To: Chris Clarke
Subject: RE: Public Meeting - Zoning By-law Amendment 407, 411, 413, 417, and 419 Maplevue Drive West

CONDO OPPOSITION PRESENTATION

APPLICATION: 407-419 MAPLEVIEW DRIVE WEST

407-419 MAPLEVIEW DR. W

SATELLITE SHOT – 391 METER HEIGHT
IMMEDIATE IMPACT ZONE – LOOKING SOUTH CURRENT VIEW
WHO WOULD WANT TO HAVE THEIR BEAUTIFUL BACKYARDS SIGNIFICANTLY IMPAIRED
LOOKING ONTO A 3.5-4.5 STOREY 15M HEIGHT CONDO?

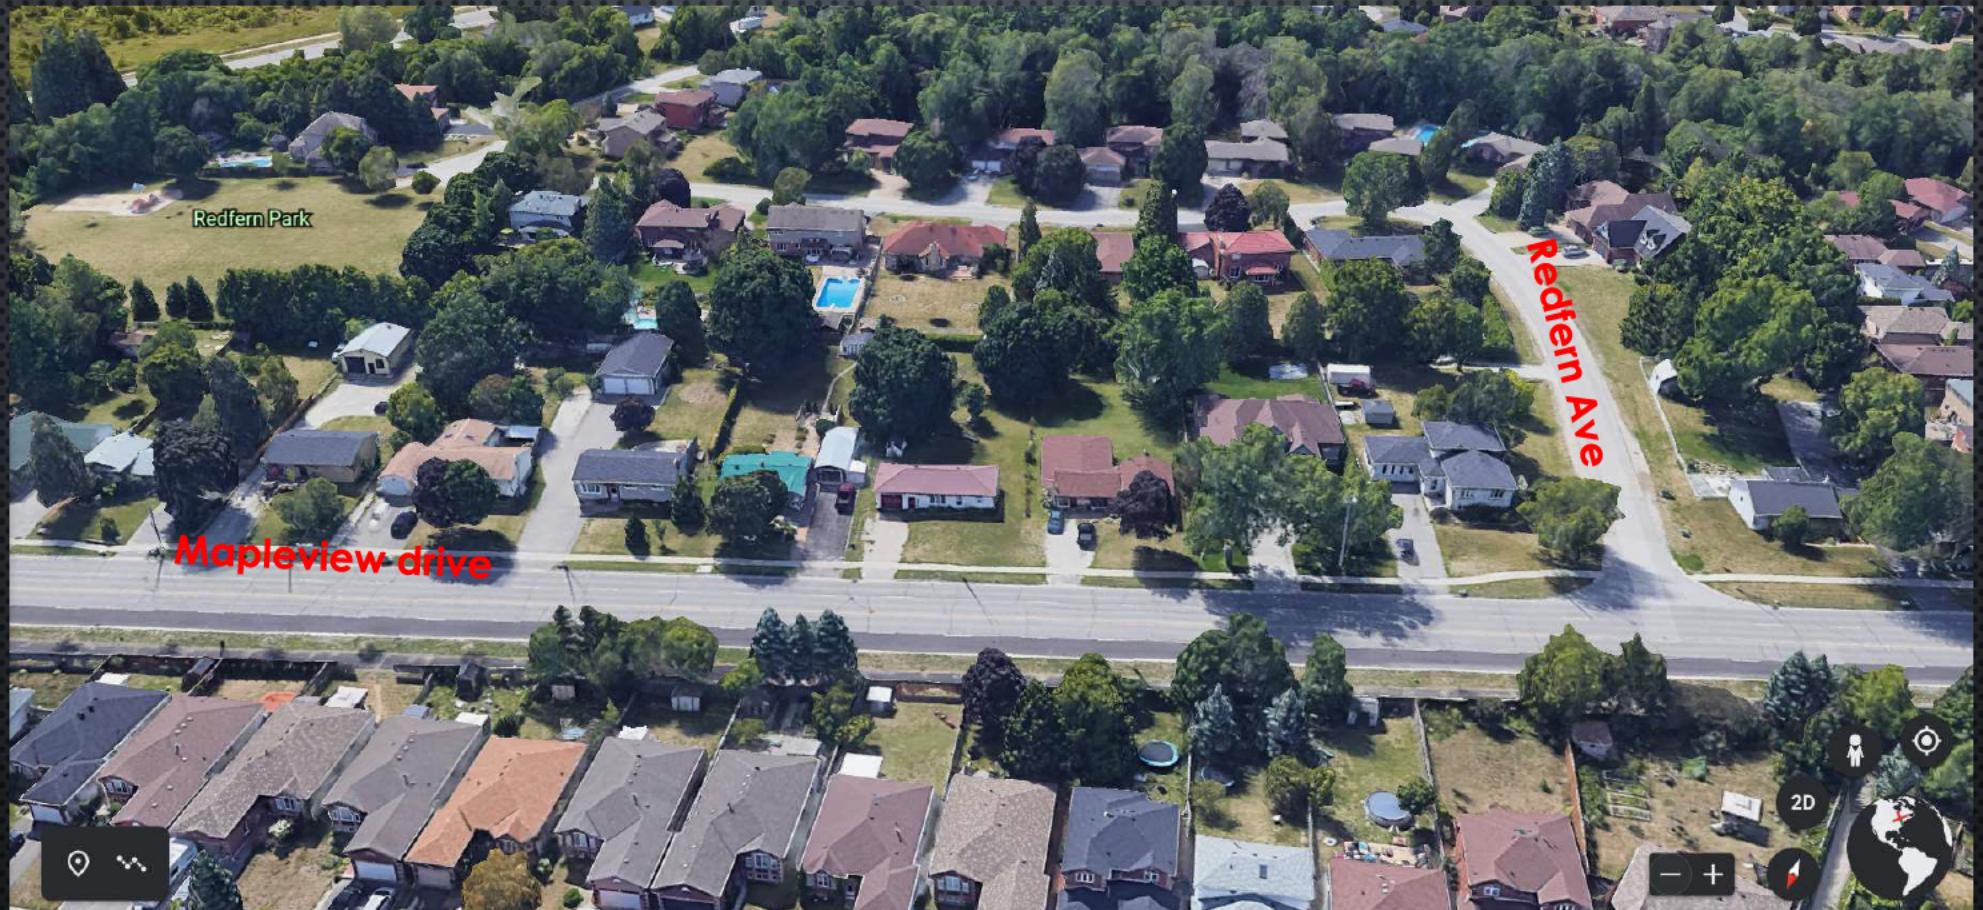
SATELLITE SHOT – 391 METER HEIGHT
IMMEDIATE IMPACT ZONE - (CONDO PICTURE IS FOR ILLUSTRATION ONLY)
WHO WOULD WANT TO HAVE THEIR BEAUTIFUL BACKYARDS CHANGED TO LOOK AT THIS?
I ASK YOU DOES THIS FIT THE NEIGHBORHOOD?

Revised Site Plan

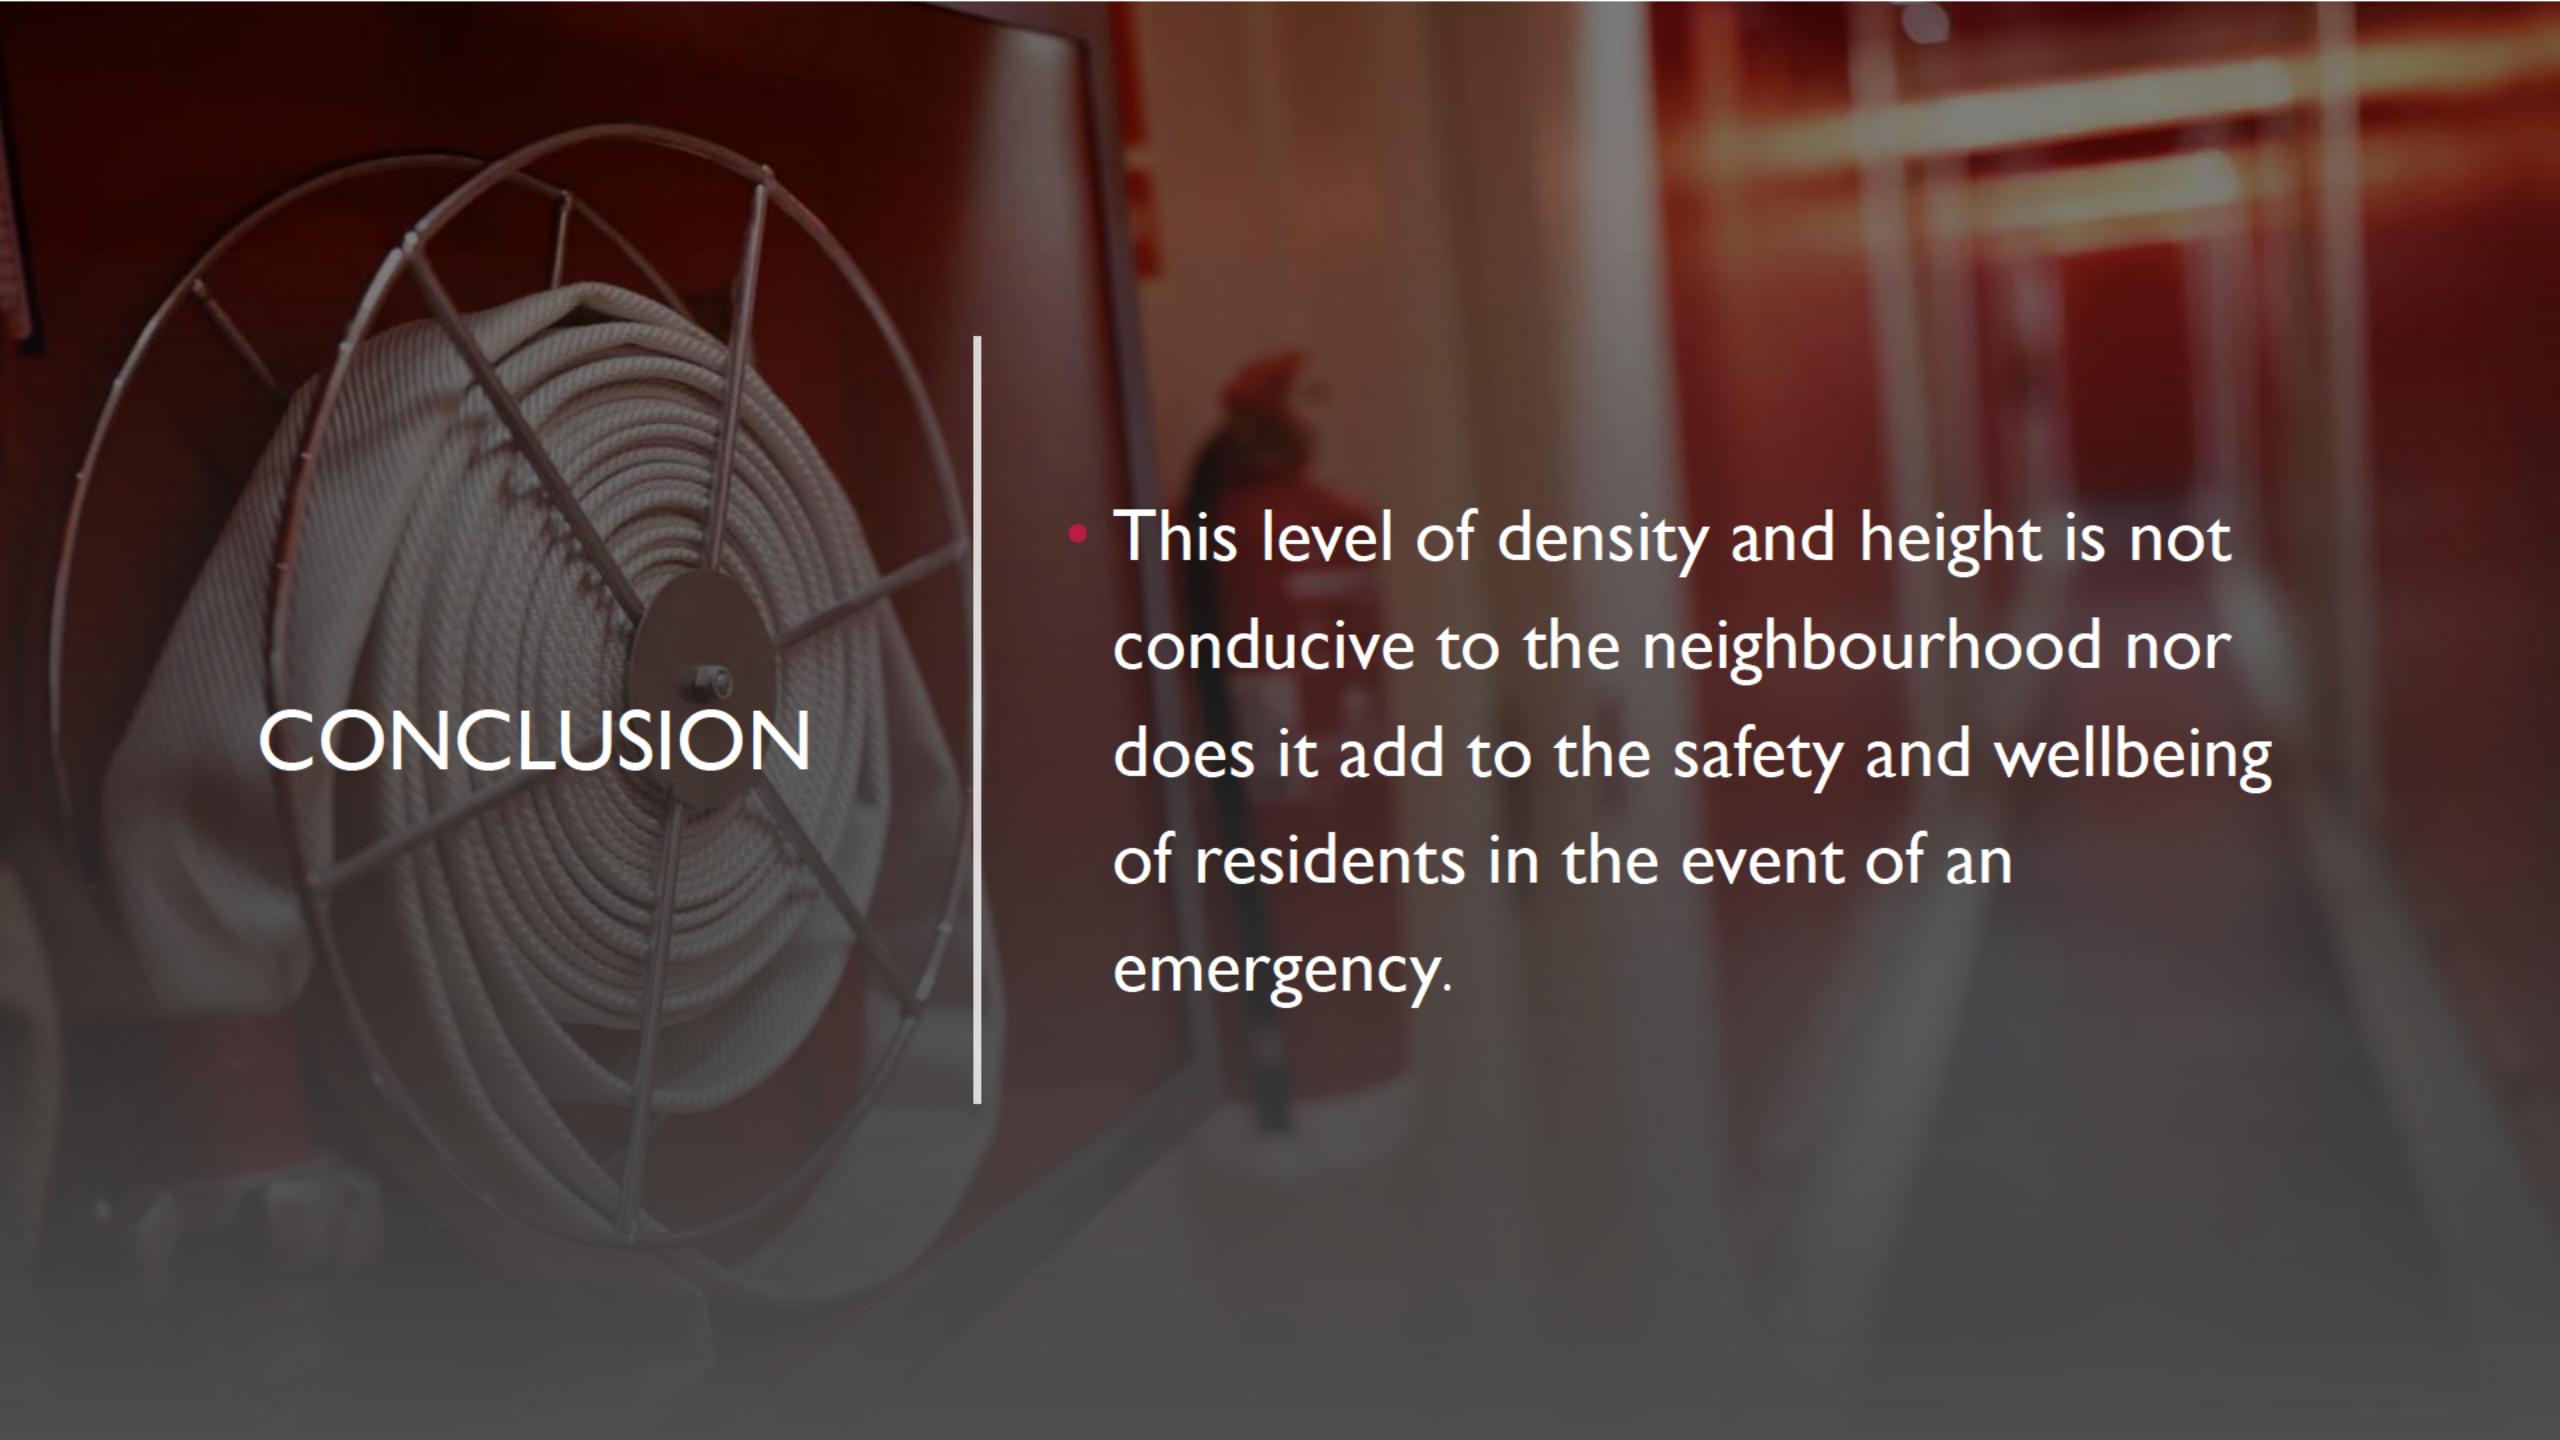
- Ingress and egress distances do not allow emergency service vehicles a safe or timely turnaround
- Hammerhead turnarounds are designed for garbage trucks not fire trucks
- Nor would they permit multiple emergency vehicles to be parked in a headfirst attitude
- Firefighting activities would need to be done from Mapleview Dr. or Redfern Ave.

- The south side of this proposal would pose a serious challenge for rescue during a balcony or rooftop fire
- A wind driven fire at any point would seriously jeopardize neighboring properties
- See next slides
